PLANNING REF: 3329/25/FUL

DESCRIPTION: Extension to existing marine retail unit to provide a new showroom & cafe on existing boat storage yard & demolition of part of building

ADDRESS: Wills Marine Ltd, The Promenade, Kingsbridge, TQ7 1JF

LETTER OF OBJECTION FROM THE SOUTH HAMS SOCIETY

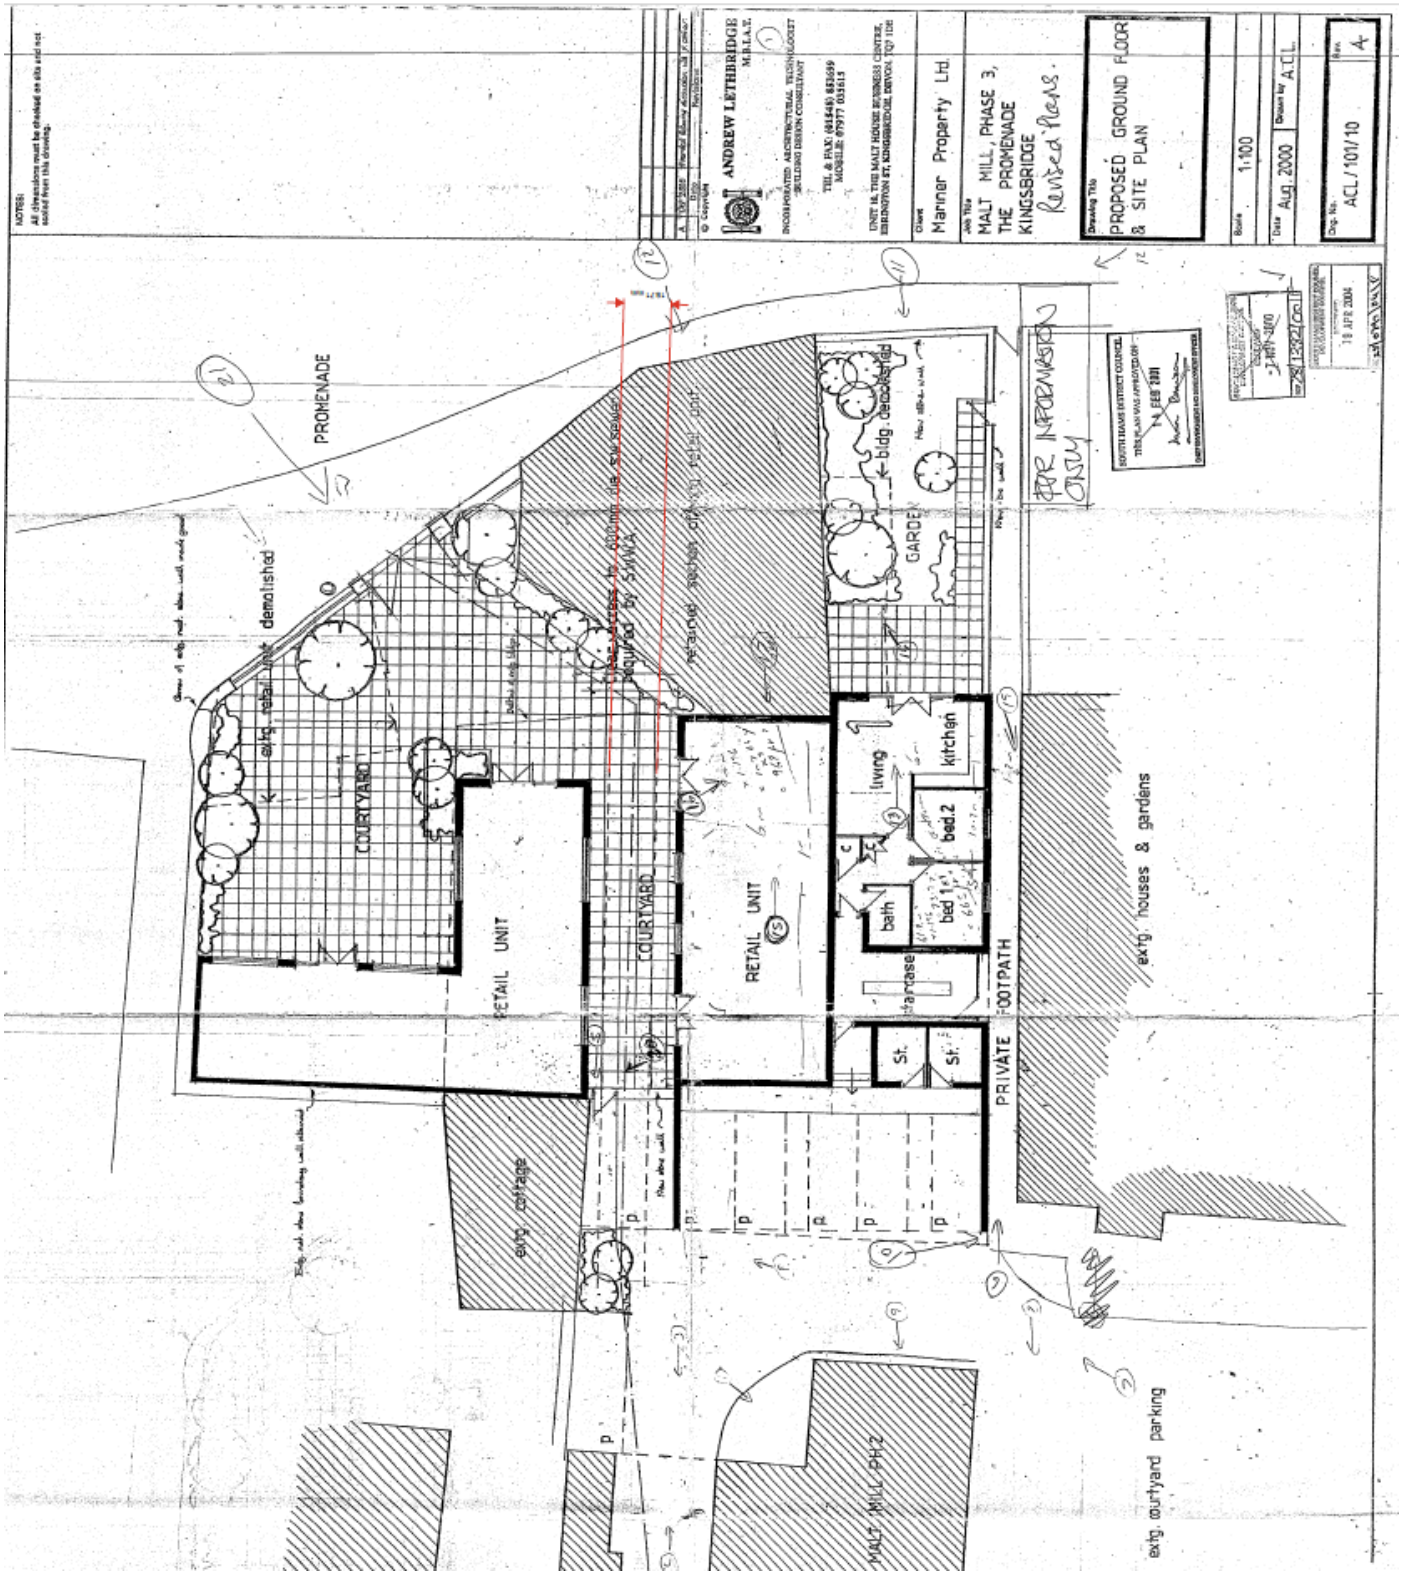
The planning permission for the two retail units (that was not implemented) shows a clear access route necessary for a surface water drain required the by SWWA between the two retail units (red line measurement added by the Society).

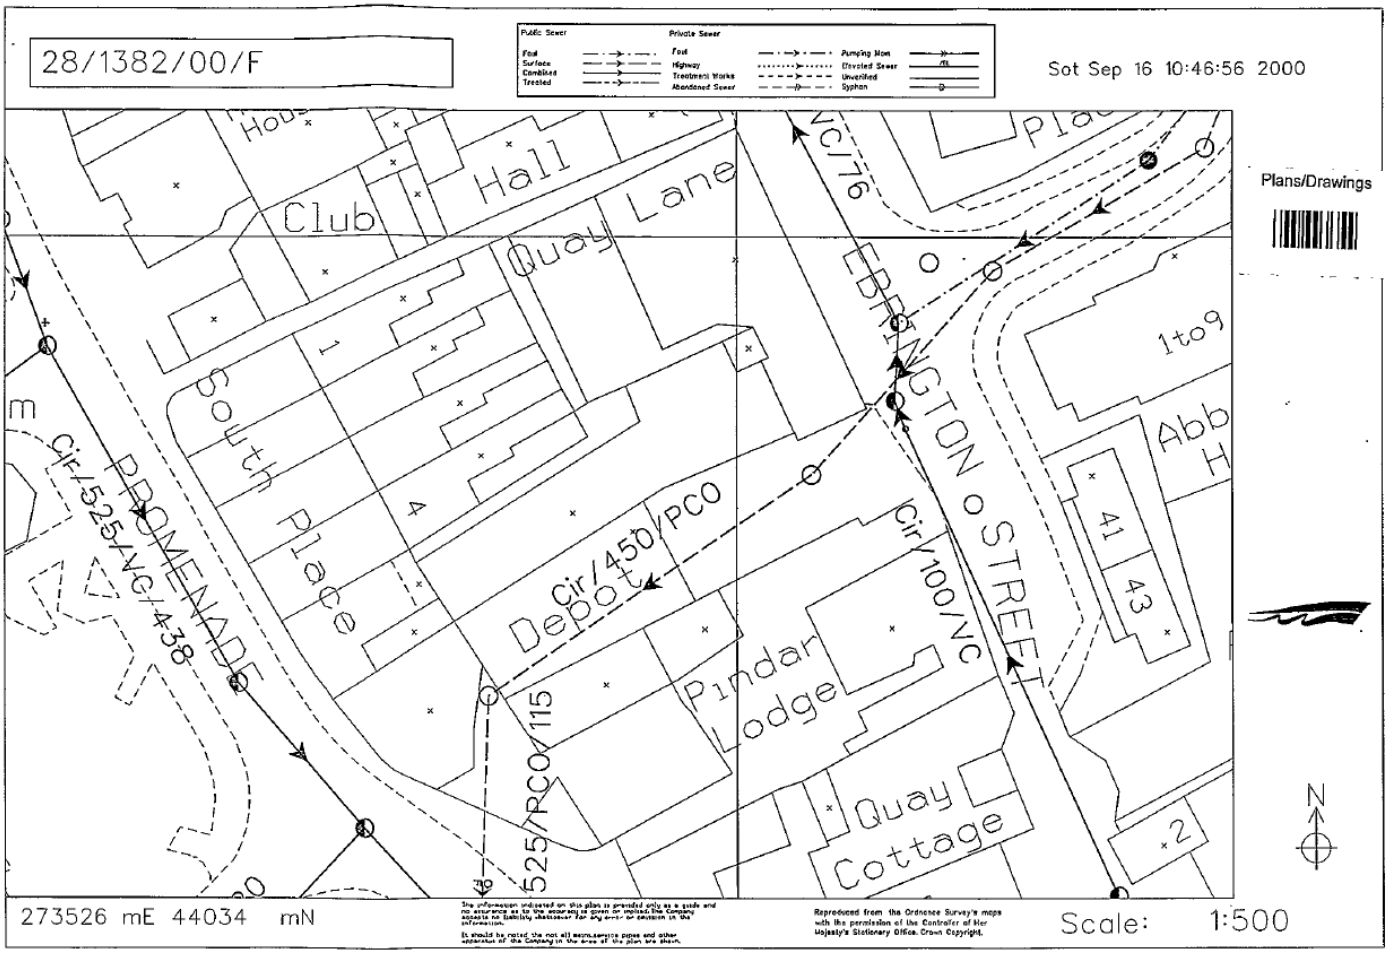
The 1999 SWW plan shows the route through the depot to the north of the Pindar Lodge Coach House.

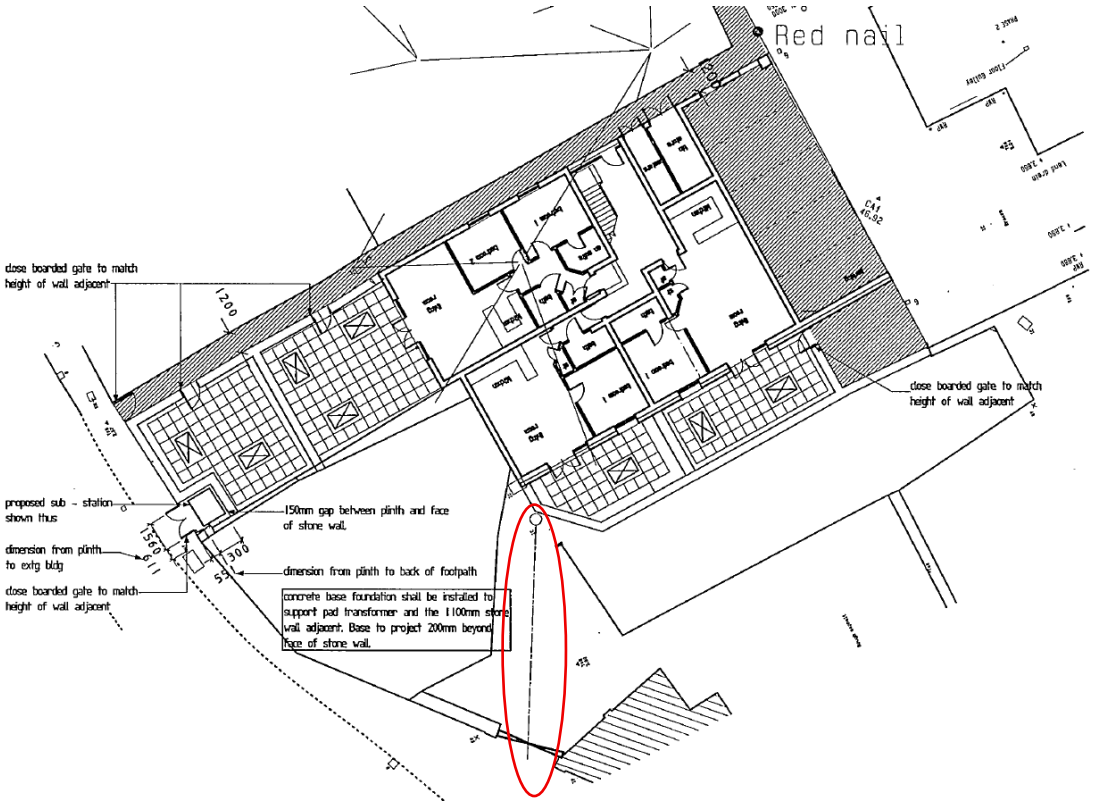
The 'as built' flats drawing – the drain runs through the court yards. The manhole and drain to the Promenade inside the red ring.

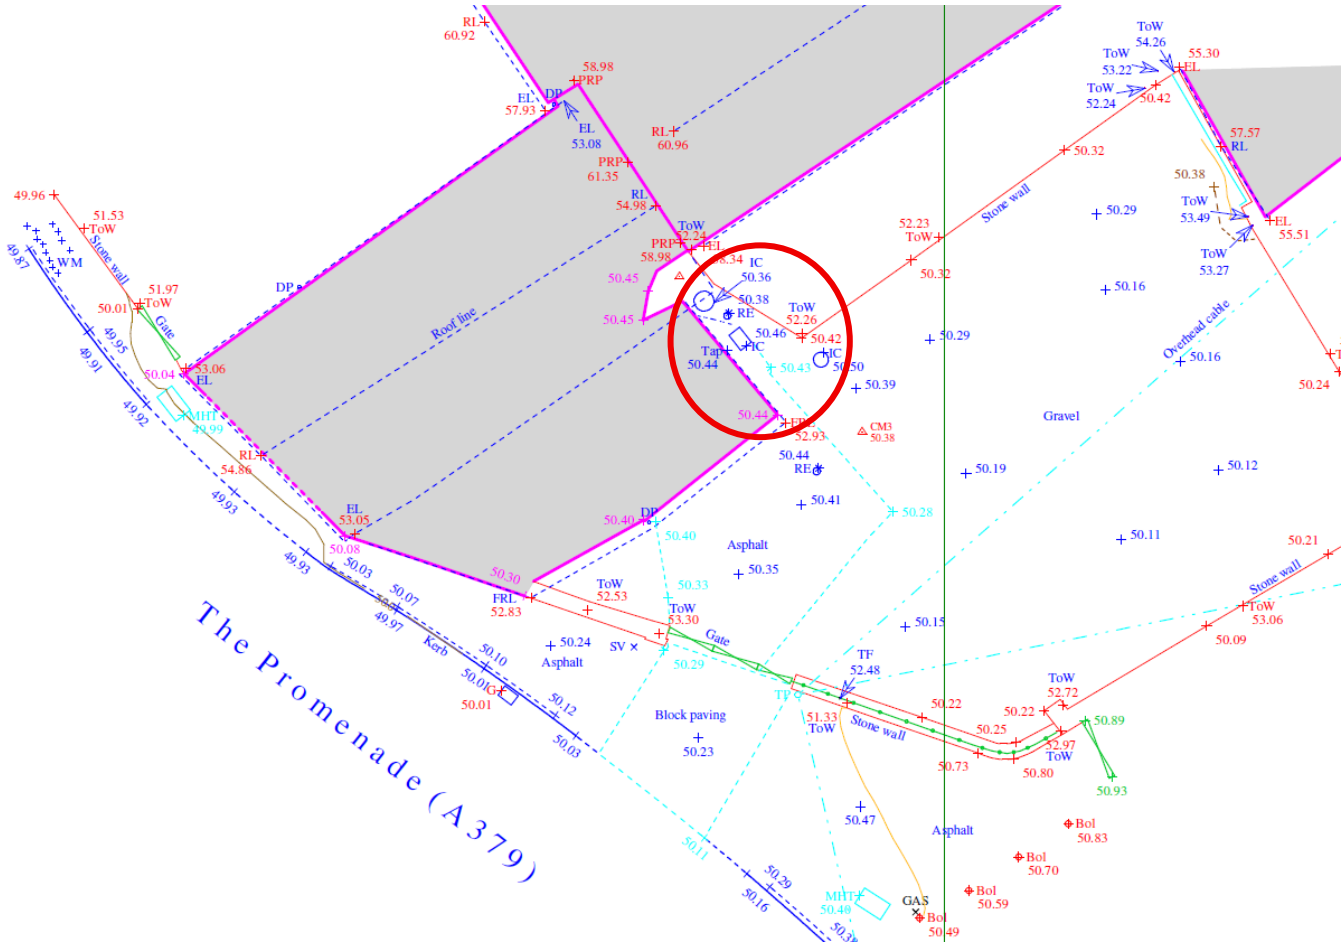
The application's submitted 'existing site plan' only illustrates manhole inspection covers in the location of the previously recorded surface water drain location.

DRAWING
EXTERNAL WORKS

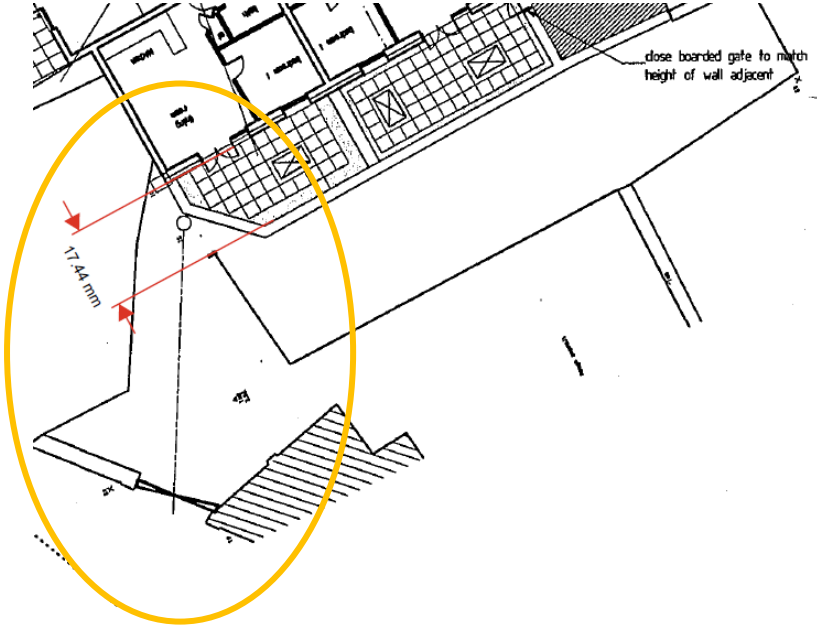
The plan for the flats built in 2004 show the courtyard to be 3.5m wide. This may be incorrect, but should be confirmed.

Proposed Ground Floor Plan
(1:100)

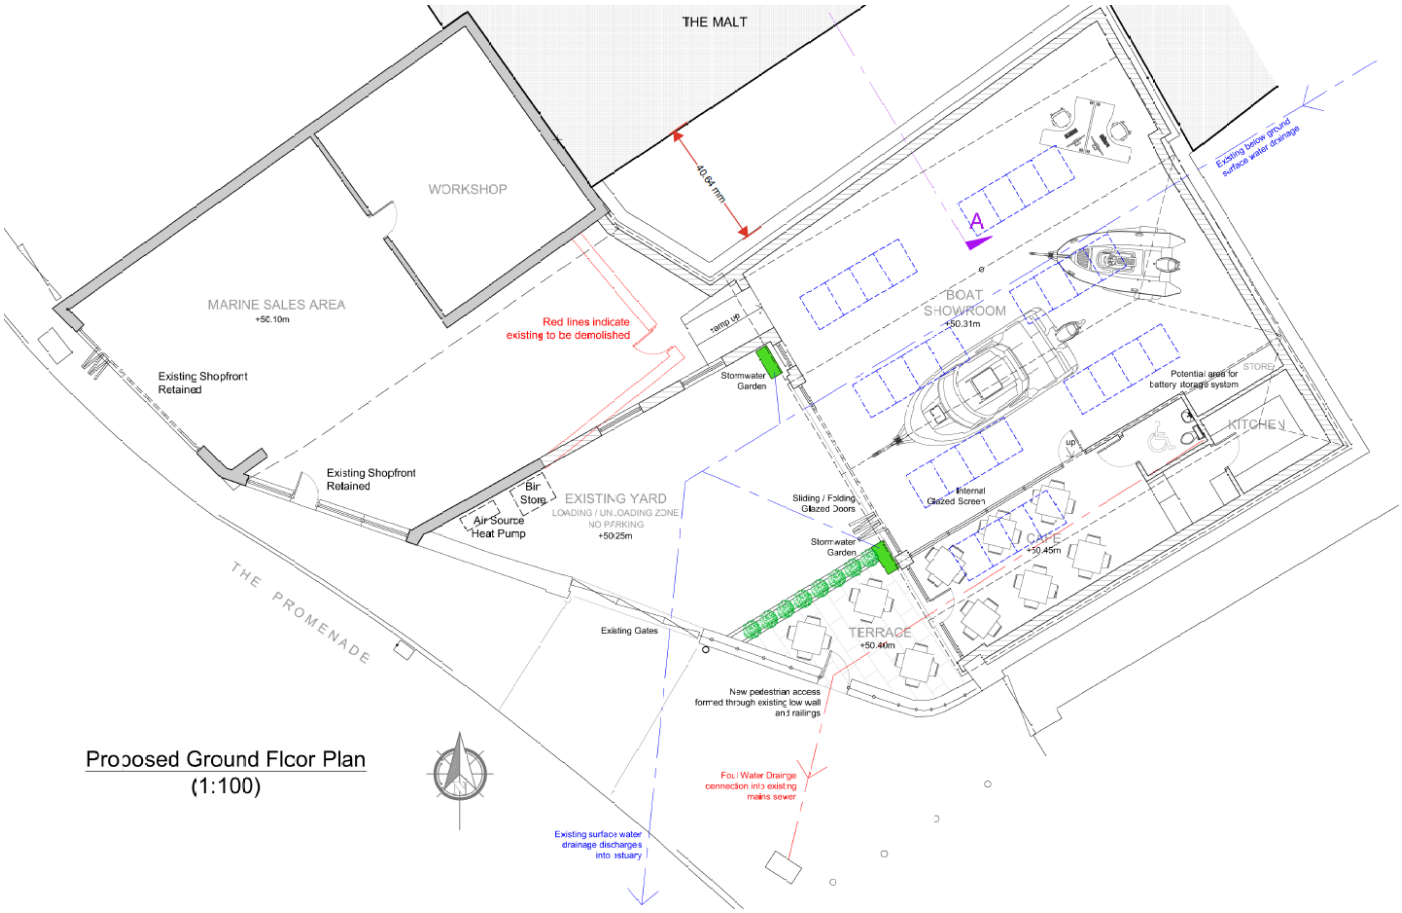
Conversely the submitted drawing shows the courtyard to be 4m wide.

Proposed Side (North West) Part Elevation (1:100)

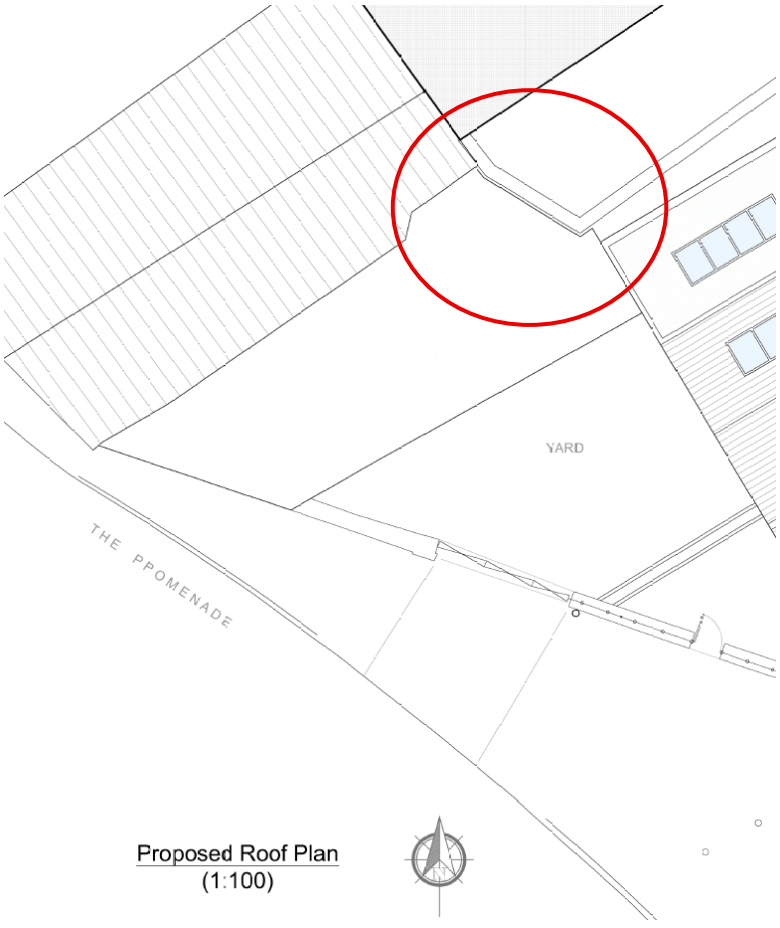
The flat roof section is illustrated to be 650mm higher than the 1.8m high stone boundary wall stated to be 1.6m.

The area in the red ring is tight to the boundary wall, higher than the existing stone wall and to the south.

The Society considers this to be unacceptable.

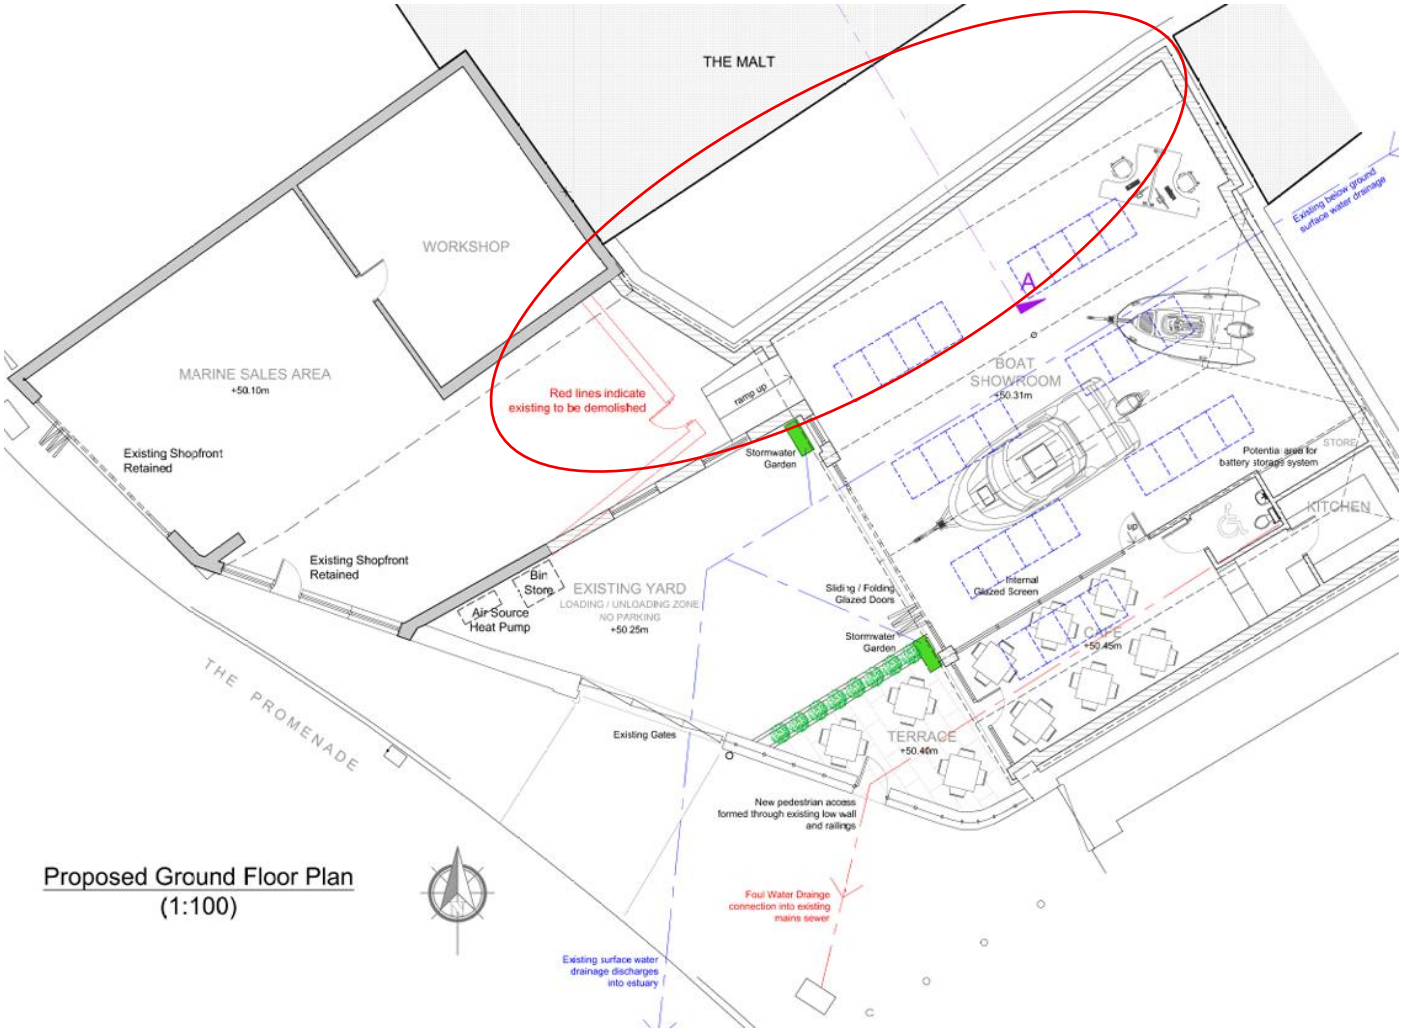
This plan shows the building wall tight to the stone boundary wall. On the roof plan, there is a gap from the stone wall to the roof. The walls of the new build surround the boundary wall.

Section A-A (1:50)

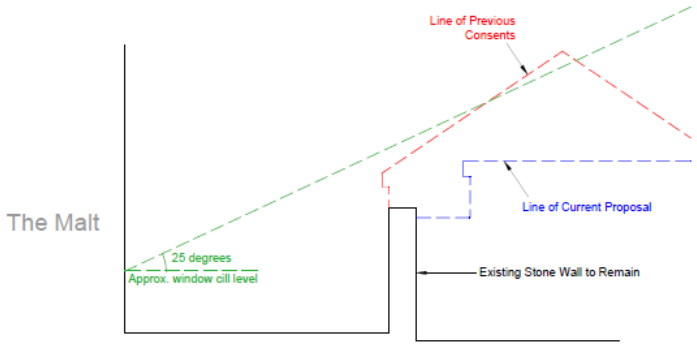
The Society finds this submission disingenuous. The previous consent was for two ground floor retail units (28/1382/00/F). The application was superseded by a planning consent for two 'one bedroom' flats and the second retail unit was removed from the plan.
